MMU Comments on NYISO's 2023-2032 Comprehensive Reliability Plan

Pallas LeeVanSchaick Joe Coscia NYISO Market Monitoring Unit Potomac Economics

October 25, 2023

Transmission Security Assessments Find Smaller Capacity Margins than Resource Adequacy

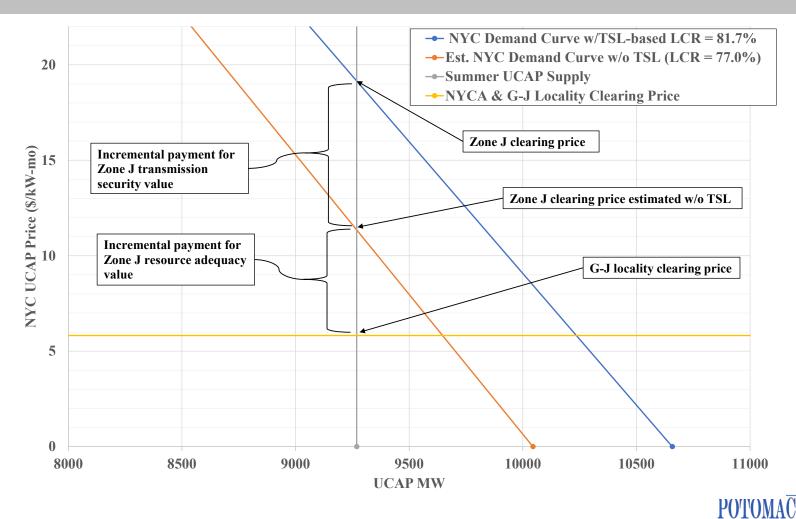
- Market design considerations:
 - ✓ ICAP requirements based on RA and TS
 - ✓ ICAP accreditation based on RA <u>only</u>

- Key factors:
 - Transfer limits
 - EOPs
 - Extreme loads
- Differences will rise because of:
 - Entry of HVDCs, wind, solar, ESRs
 - Proposed use of 90/10 load forecast in TS
